# **PART 2 AMENDMENT: AS PART OF THE PROPOSED LUTZBURG SOLAR POWER PLANT NEAR OLIFANTSHOEK IN THE NORTHERN CAPE PROVINCE**

**DEA Reference No.** : 14/12/16/3/3/2/938/AM1

**Report Status** : Final Motivational Report

**Figure 3.1:** Proposed amendments

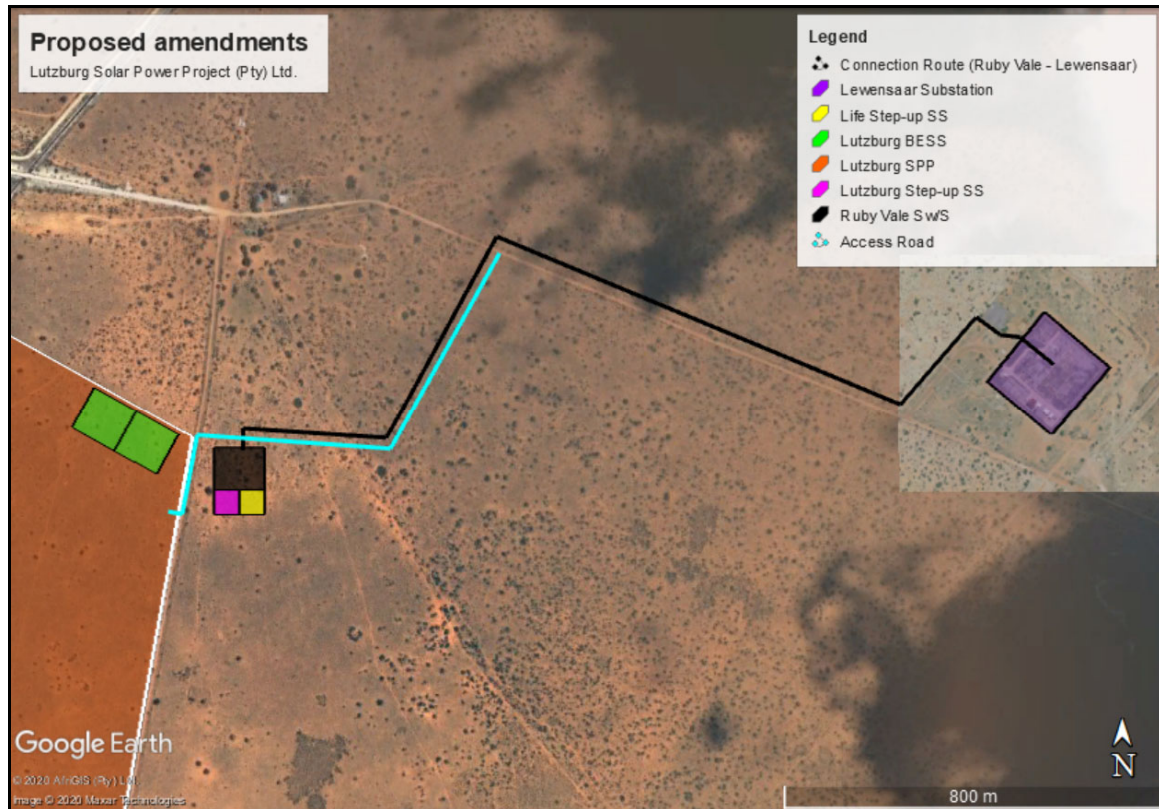
The following amendments are being applied for in terms of the EIA Regulations, 2014 (as amended in 2017)(refer to Figure 3.1):

- Inclusion of a battery storage system

The capacity of the battery storage facility per project will be kept in standard shipment containers or smaller containers (“blocks”) as might be proposed by selected supplier with an area of approximately 2ha. The battery to be installed will be lithium-ion and no electrolytes will be transported to and handled on site. Battery cells will be assembled at the supplier factory prior to delivery to the sites. The battery storage facility will be located within the already authorized PV plant footprint area (refer to Figure 3.2 for the corner coordinates of the proposed BESS). There will be no need for the additional clearance of more than 2 ha of vegetation for the development of a new area for the battery storage facility.

**Figure 3.3:** Micro-citing of the Power Line within approved 52m corridor

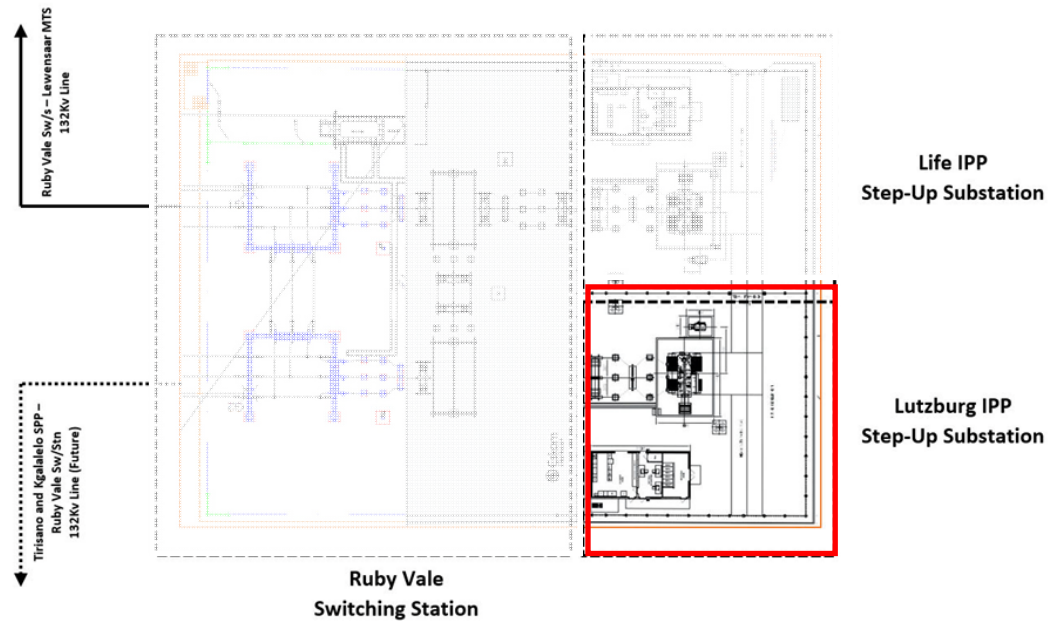
- Micro-citing the approved connection line

After receiving the Cost Estimate Letter for Grid connection and Supply from Eskom, it became apparent that the proposed Lutzburg Solar Facility cannot connect straight into Lewensaar MTS. It was therefore proposed that the Lutzburg Solar Facility must first connect to the Ruby Vale Switching station (located adjacent to the Lutzburg SPP) from where the connection line will connect to Lewensaar MTS. The approved power line route therefore simply needs to be micro-cited slightly within the already approved 52m corridor as indicated in Figure 3.3 below. The length of the power line route remain the same – at approximately 2.5km.

**Figure 3.4:** Lutzburg substation (figure for illustration purposes only)

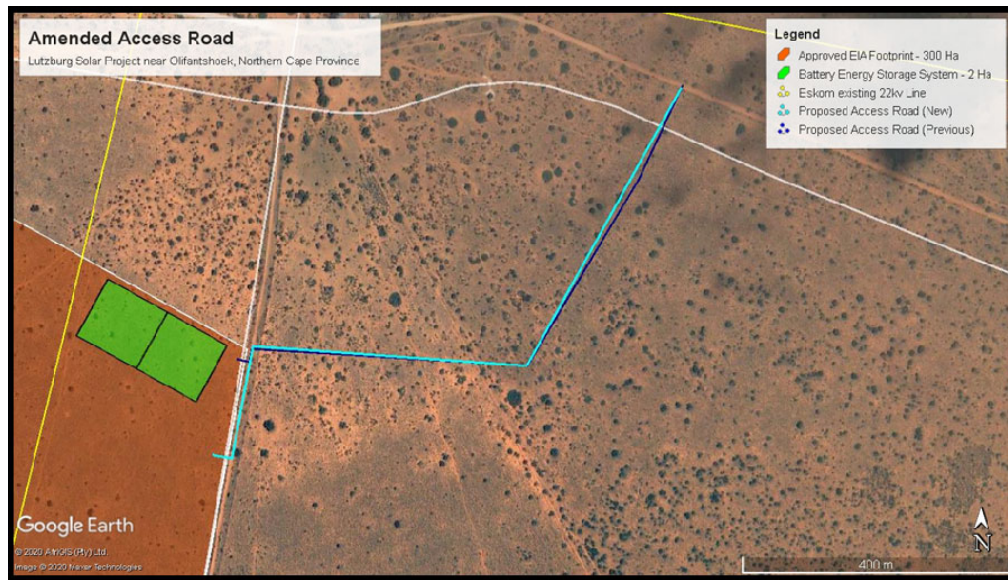
- Increase of Substation footprint and description to accommodate for IPP Step-up Substation and Switching Station

The proposed on site substation will be situated adjacent to the site as indicated in figure 3.2 and will have a combined footprint of approximately 500m<sup>2</sup>. The substation will consist of an IPP Step-up substations that will connect to the Switching Station that is authorised as part of an adjacent project (Life SPP). The Lutzburg step-up substation will step-up the generated capacity to 132Kv in order to connect and supply at the same Voltage at the Lewensaar MTS (after constructing a 132Kv feeder bay). The Switching

Station will be the connection between the Step-up Substation and the Lewensaar MTS (refer to figure 3.4 for an illustration of the location of the substation infrastructure). It should be noted that Life and Lutzburg solar facilities (projects located adjacent to each other) will each have independent connection points into the switching station.
